Re: Letter of Correspondence #1  
Site Plan Review  
Shared Maintenance Facility  
185 Windham Center Road, Windham, Maine

**SITE LAYOUT & UTILITY PLAN**

**GRADING, DRAINAGE, AND EROSION CONTROL PLAN**

# C-5

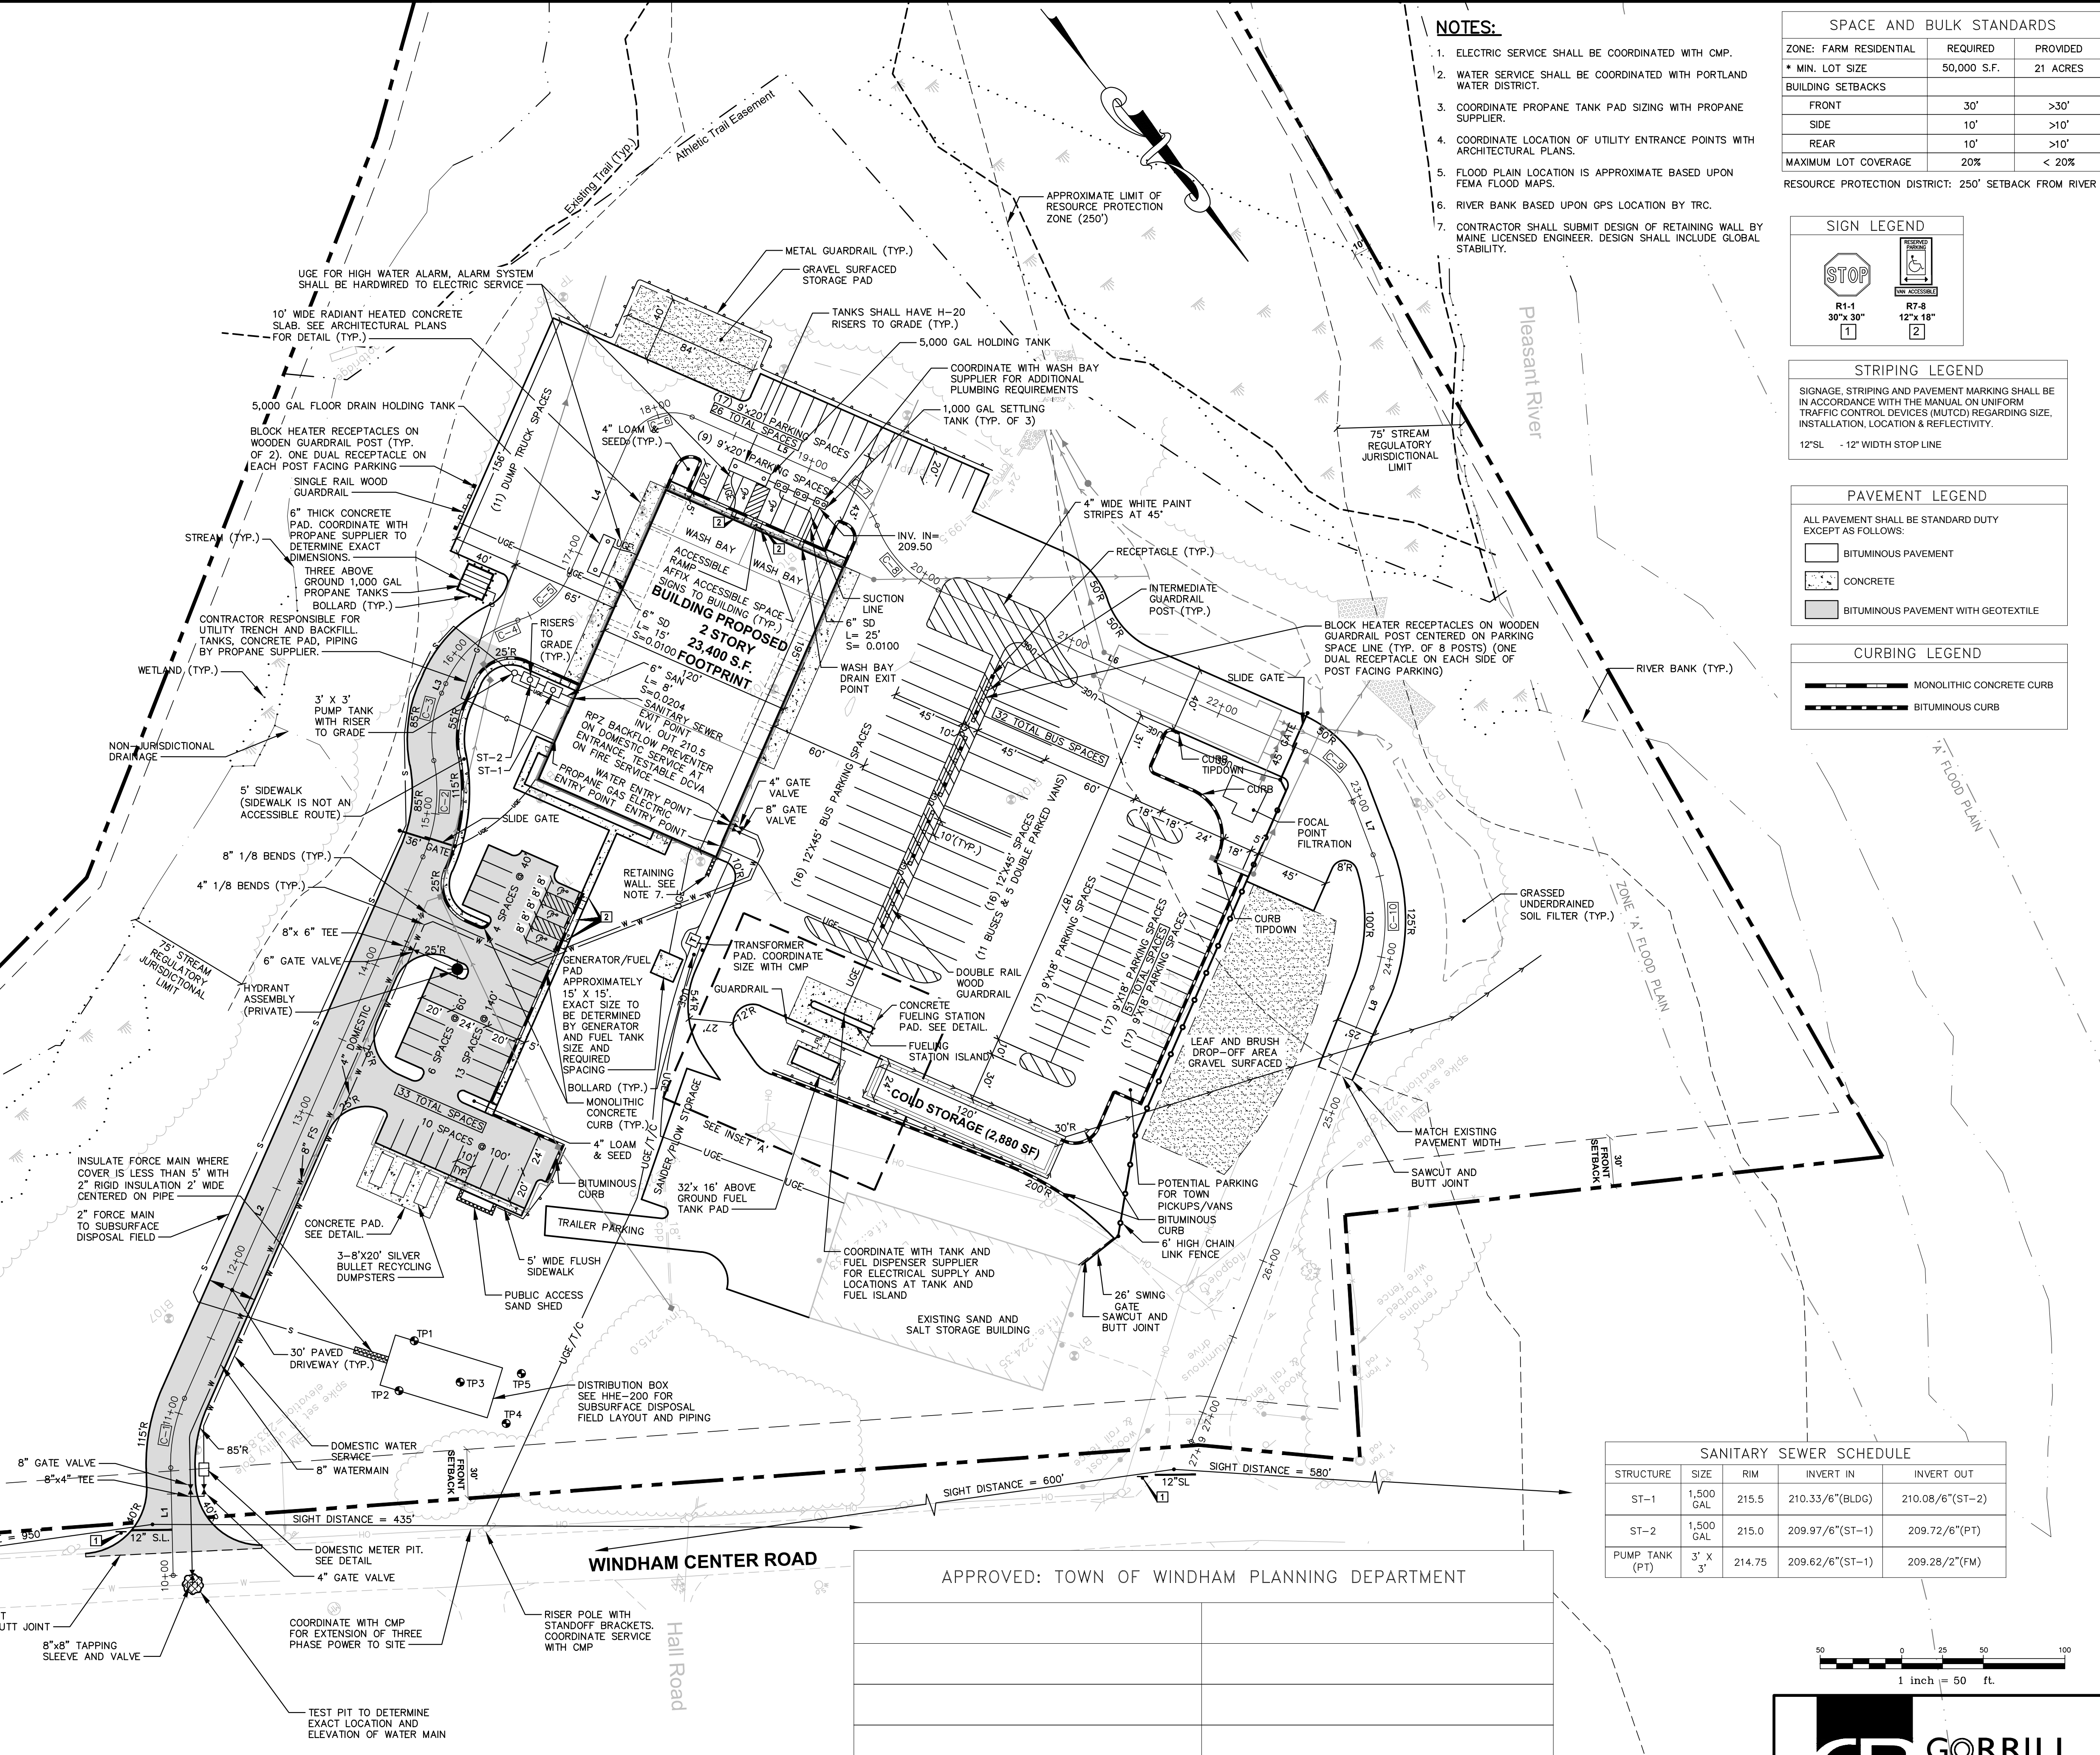
Based upon comments received at the planning board meeting on April 23, Gorrill Palmer has prepared revised plans showing an option for relocation of the fuel tanks, and a discussion of the site impacts within the stream buffer area. The following narrative presents our response.

The Site Layout and Utility Plan, and the Grading, Drainage, and Erosion Control Plan attached to this letter contain an option for the location of the fuel tanks and dispensers. Given the location of the existing Public Works site and the constraints of the site layout, any location on the site is tributary to either the Pleasant River or the unnamed stream (which is also tributary to the river). The location of the fueling station shown on the revised plans is roughly as far from the Pleasant River or the stream as is possible for this site. The proposed location is tributary to the Focal Point filtration system which would provide an opportunity for containing any spills before they reach the river. The Focal Point system is lined with an impermeable liner and contains an outlet control valve on the chamber system underdrain that could be closed in the event of a spill. The additional flow path across the parking lot provided by this option presents an opportunity to intercept a spill with oil absorbent booms which are kept on-site for spill control as part of the site's Spill Prevention Control and Countermeasure Plan. As with the original layout, the fuel system will consist of dual wall tanks that are electronically monitored for leakage, dual wall piping that is electronically monitored for leakage, and collection sumps at fuel tank filling and valve locations. The dispenser pumps are equipped with automatic shut off valves that will shut off fuel flow if a dispenser hose is damaged. The original fuel system location is being reviewed by the MDEP for its siting and for the Spill Prevention Control and Countermeasure Plan for this site. The revised system location would need approval from MDEP (as a Minor Revision) if the revised location was preferred by the Town. It is our position that either location of the fueling station is safe and an improvement over the existing condition.
